SUBJECT: Former Desert Petroleum Site, 2844 Mountain Boulevard
Oakland, CA 94602

**SUPPLEMENTAL
RISK BASED CORRECTIVE ACTION REPORT
for**

**2844 Mountain Boulevard
Oakland, CA**

Fig 4

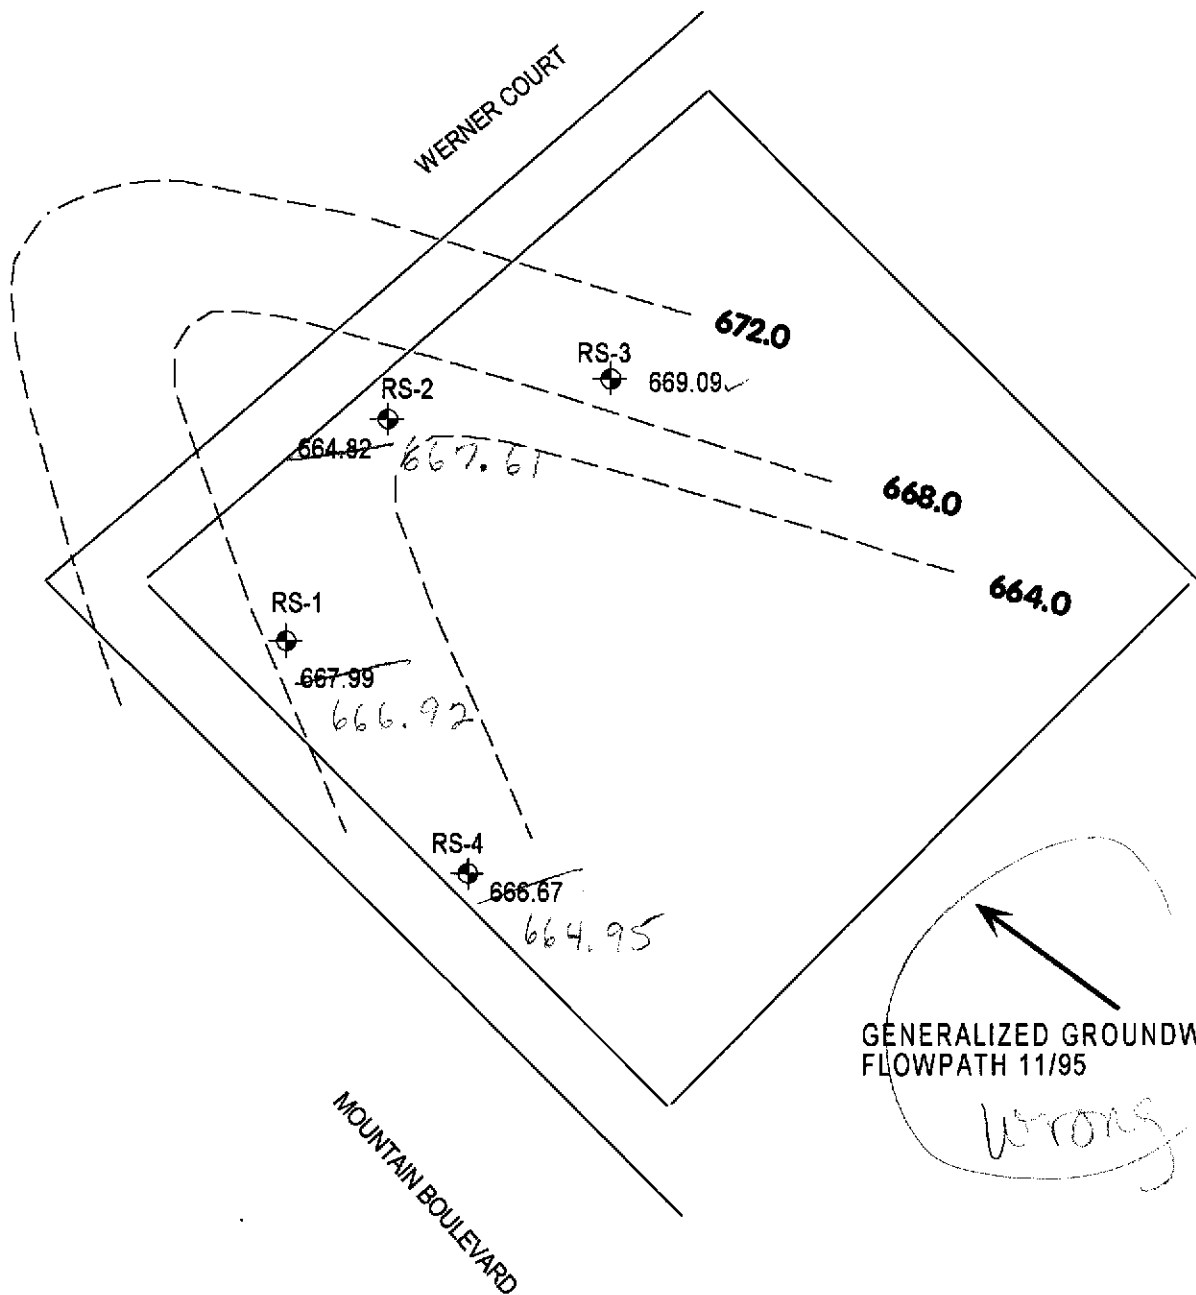
incorrect
